# Recommendations for Preferred Concept *Circulation Working Group*

## CAC Members of Circulation Working Group:

*Image above: This is an example of where a path already exists that could be used as a connector for people on bikes to travel from Upton to Cedar Lake Trail, as one possible routing/solution.*

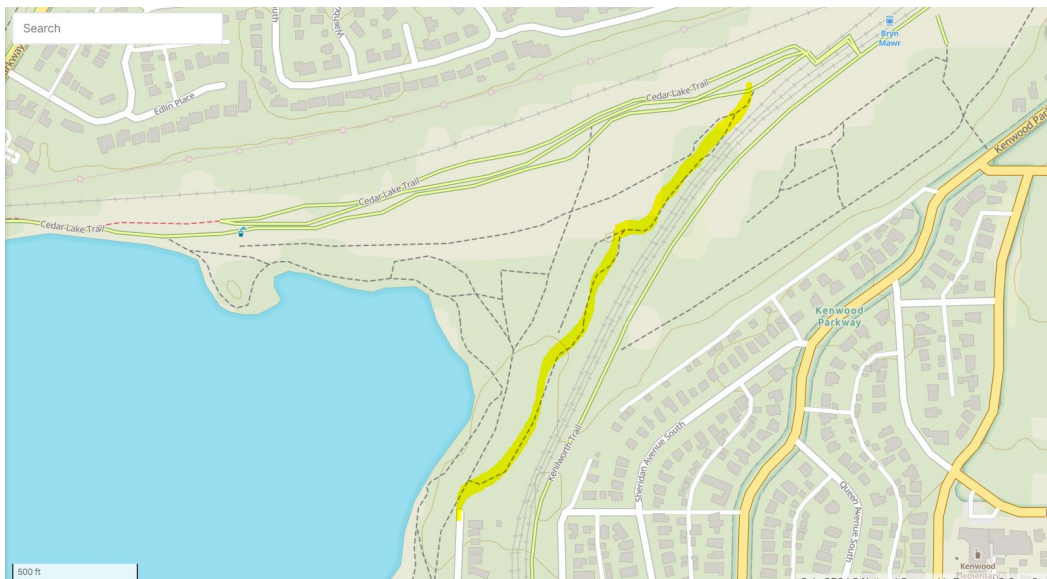
3. People who bike are current users of this park. To ensure safety for all users and eliminate conflicts between pedestrians and bicyclists in the natural areas between 21st Street and the Cedar Lake Trail, **the Circulation Working Group recommends creating a sustainable, clearly separated, natural surface bike route that connects cyclists at Cedar Lake East Beach (west of LRT station) near 21st street northbound to the Cedar Lake Trail.** The new path will allow cyclists a safe route, while physically separating them from pedestrians on nearby soft-surface paths.

*Image Above: This is another example of a well-constructed boardwalk. This example extends slightly/hovers over a lake.*

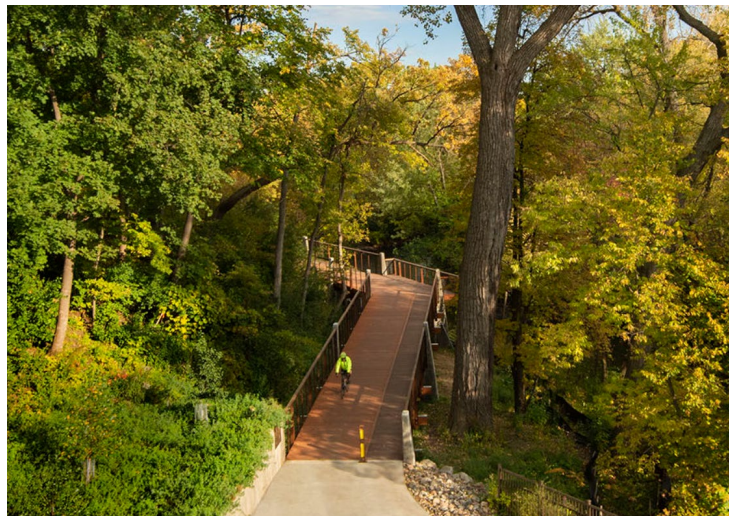
4. To eliminate pedestrian and cyclist conflicts and perceived threats from closeness of motor vehicles in the NW corner of Cedar Lake, the **Circulation Working Group** suggests moving pedestrian traffic onto a well-constructed, year-round boardwalk between the north end of Point Beach parking lot and the Cedar Lake Trail.

Image above: Southeast shoreline of Cedar Lake delineating park property and private property.

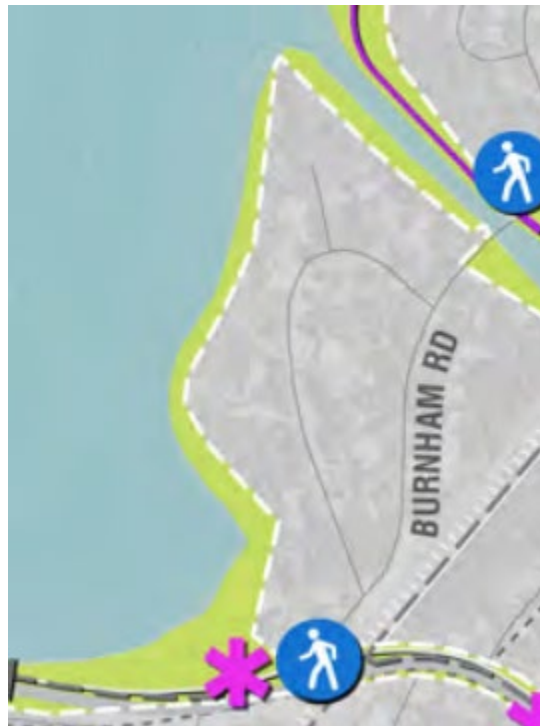
Last fall the Park Board took a step in setting right this historical error by adopting a plan to end all encroachments on the SE shore of Cedar lake upon the sale or transfer of each property. **The Circulation Working Group believes that process will take too long, likely extending 40 or more years before the last of the encroachments is cleared. Recognizing that private landowners have only done what the Park Board has permitted them to do, we believe the Park Board should revise its plan and recommend all encroachments be terminated in 10 years, which allows a generous severance arrangement given that the Park Board has the legal right to terminate all encroachments immediately. All private docks, stairways, terraces, boat racks, and other structures changing the shoreline should be removed and the shoreline consistently restored to a more natural condition.**

To respect both the private and public land involved, the boundary between the public land and private land should be marked with a low (to preserve views of the lake) wood fence including gates, as needed, to permit the private landowners to access the shore. Such a fence will announce to the public the areas of public land restored to public use, such as a future walking path.
